Proposed Class 2 Resource Conservation and Recovery Act (RCRA) Permit Modifications and Request for Temporary Authorization at the 183-H Solar Evaporation Unit

**PROPOSED CLASS 2 RESOURCE CONSERVATION AND RECOVERY ACT (RCRA)
PERMIT MODIFICATIONS AND REQUEST FOR TEMPORARY AUTHORIZATION AT
THE 183-H SOLAR EVAPORATION UNIT (TSD: T-1-4)**

**Part VI, Closure Unit 2
183-H Solar Evaporation Basins**

9 **Figure 3.1. Location Map for 100-H Area Monitoring Wells**

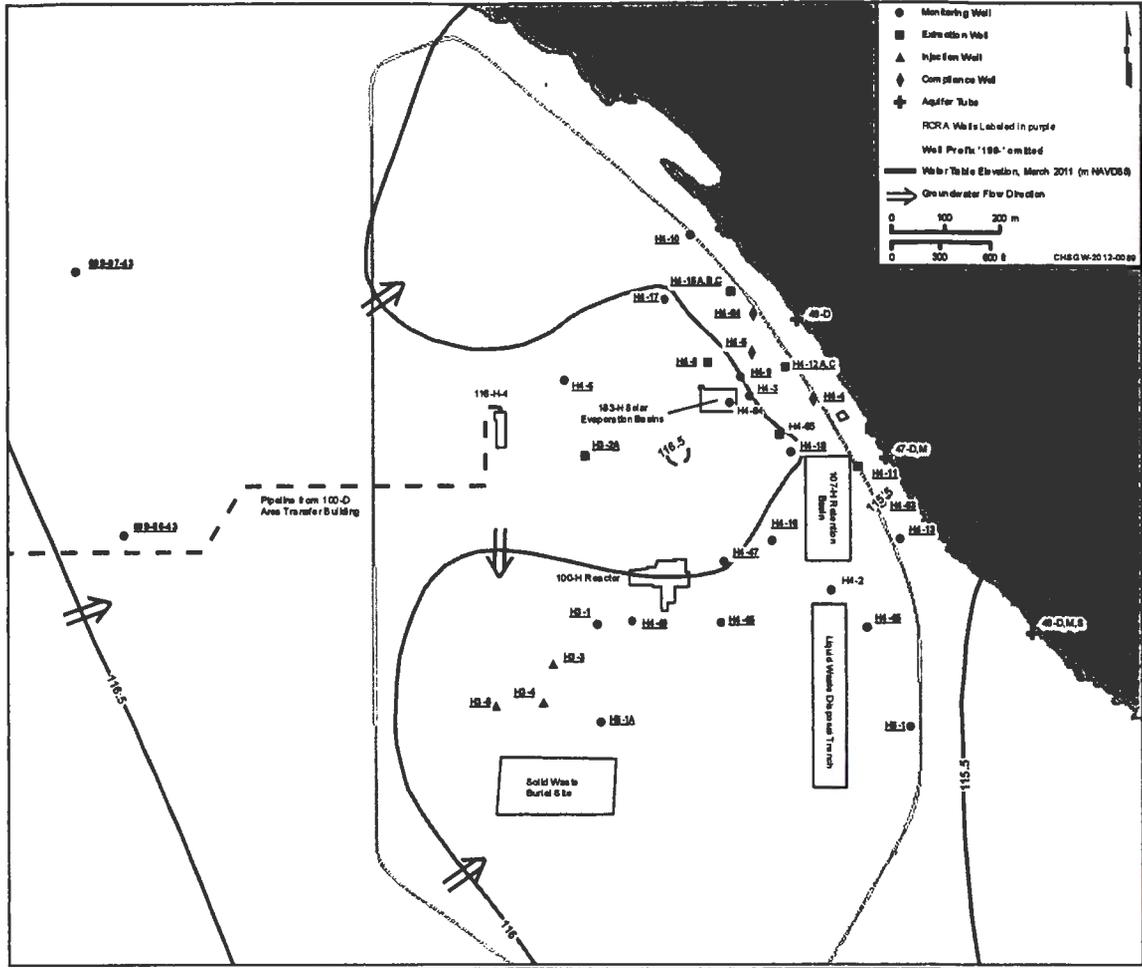
This letter also requests a temporary authorization under WAC 173-303-830(4)(e)(ii)(A)(I) to discontinue use of groundwater monitoring well 199-H4-3 and instead use well 199-H4-84 by February 15, 2013. This will ensure that there is no impact to on-going waste site remediation activities in the 100-H Area. DOE believes that temporary authorization is warranted to facilitate timely implementation of closure or corrective action activities, pursuant to WAC 173-303-830(4)(e)(iii)(B)(I). Enclosure 2 contains the outline addressing how compliance will be maintained in accordance with WAC 173-303-830(4)(e)(ii)(B)(III).

Hanford Facility RCRA Permit Modification Notification Form					
Unit: 183-H Solar Evaporation Basins	Permit Part Part VI, Post Closure Unit 2				
<p><u>Description of Modification:</u> Chapter 3.0, Figure 3.1:</p> <p style="text-align: center;">Figure 3.1. Location Map for 100-H Area Monitoring Wells</p> <p>Changes to this figure have been made to maintain consistency with Section 3.2</p>					
WAC 173-303-830 Modification Class ^{1 2}		Class 1	Class 1 ¹	Class 2	Class 3
Please mark the Modification Class:				X	
<p>Enter relevant WAC 173-303-830, Appendix I Modification citation number: C.1.a</p> <p>Enter wording of WAC 173-303-830, Appendix I Modification citation:</p> <p>Changes in the number, location, depth, or design of upgradient or downgradient wells of permitted groundwater monitoring system. Removal of well 199-H4-3 from the RCRA groundwater monitoring network and replacement with 199-H4-84 reflects changes made during 2011 remedial investigation activities. Well 199-H4-3 needs to be decommissioned, because it interferes with the 100H Area waste sites excavation footprint. Well 199-H4-84 is closer to the waste site and should better represent groundwater conditions. The CERCLA pump & treat system is connected to 199-H4-12C, not 199-H4-12A. Well 199-H4-12A is completed in the unconfined aquifer, where hexavalent chromium concentrations are low. Well 199-H4-12C is completed in the confined aquifer within Ringold Upper Mud unit, where hexavalent chromium concentrations were found to be above 100 ppb. Well H4-7 is being removed from the figure to reflect its scheduled decommissioning from the CERCLA interim action network to support vadose zone remediation activities in the 100-H Area. The figure is also being updated to current DOE and CHPRC cartographic standards (river arrows, color changes, legend changes, etc.). Changes to the figure reflect the operation of the new HX pump and treat system and revisions to the CERCLA and RCRA monitoring networks.</p>

Figure 3.2. Predicted Groundwater Flow During Interim Remedial Measure

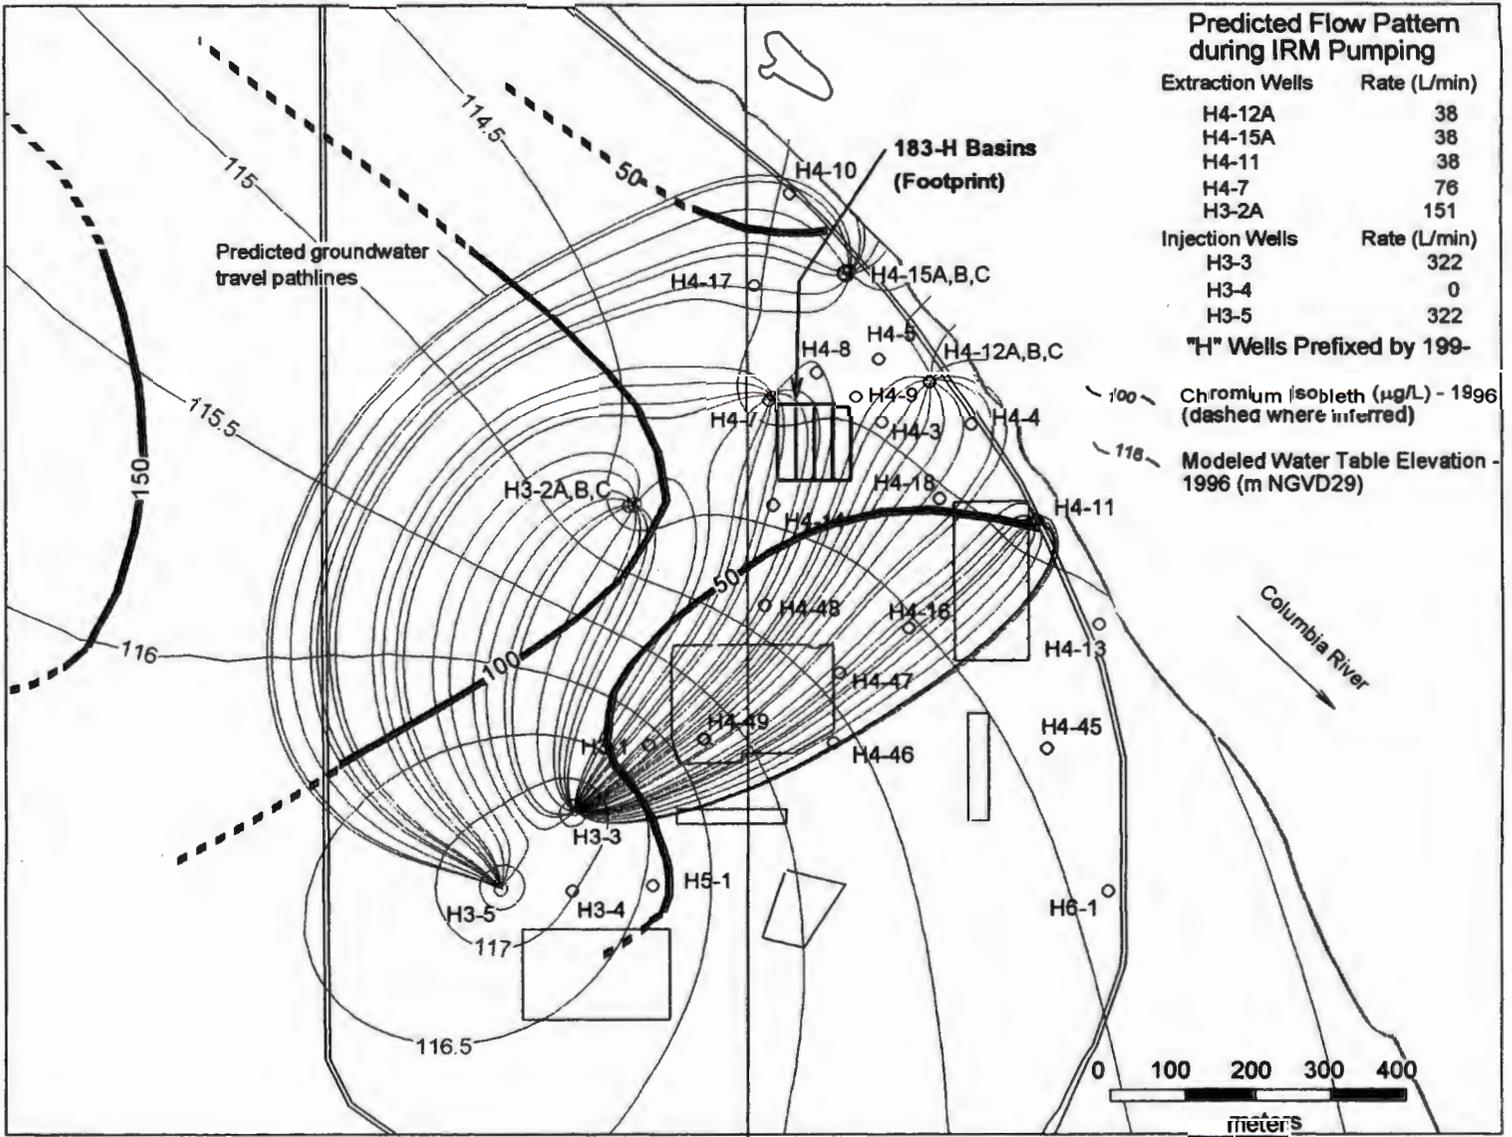
Hanford Facility RCRA Permit Modification Notification Form				
Unit: 183-H Solar Evaporation Basins	Permit Part Part VI, Post Closure Unit 2			
<p><u>Description of Modification:</u> Chapter 3.0, Figure 3.2:</p> <p style="text-align: center;">Figure 3.2. Location Map for 100-H Area Monitoring Wells</p> <p>Changes to this figure have been made to maintain consistency with Section 3.2</p>				
WAC 173-303-830 Modification Class ^{1 2}	Class 1	Class '1	Class 2	Class 3
Please mark the Modification Class:			X	
<p>Enter relevant WAC 173-303-830, Appendix I Modification citation number: C.1.a Enter wording of WAC 173-303-830, Appendix I Modification citation: Changes in the number, location, depth, or design of upgradient or downgradient wells of permitted groundwater monitoring system. Removal of well 199-H4-3 from the RCRA groundwater monitoring network and replacement with 199-H4-84 reflects changes made during 2011 remedial investigation activities. Well 199-H4-3 needs to be decommissioned, because it interferes with the 100H Area waste sites excavation footprint. Well 199-H4-84 is closer to the waste site and should better represent groundwater conditions. The CERCLA pump & treat system is connected to 199-H4-12C, not 199-H4-12A. Well 199-H4-12A is completed in the unconfined aquifer, where hexavalent chromium concentrations are low. Well 199-H4-12C is completed in the confined aquifer within Ringold Upper Mud unit, where hexavalent chromium concentrations were found to be above 100 ppb. Well H4-7 is being removed from the figure to reflect its scheduled decommissioning from the CERCLA interim action network to support vadose zone remediation activities in the 100-H Area. The figure is also being updated to current DOE and CHPRC cartographic standards (river arrows, color changes, legend changes, etc.). Changes to the figure reflect the operation of the new HX pump and treat system and revisions to the CERCLA and RCRA monitoring networks.</p>
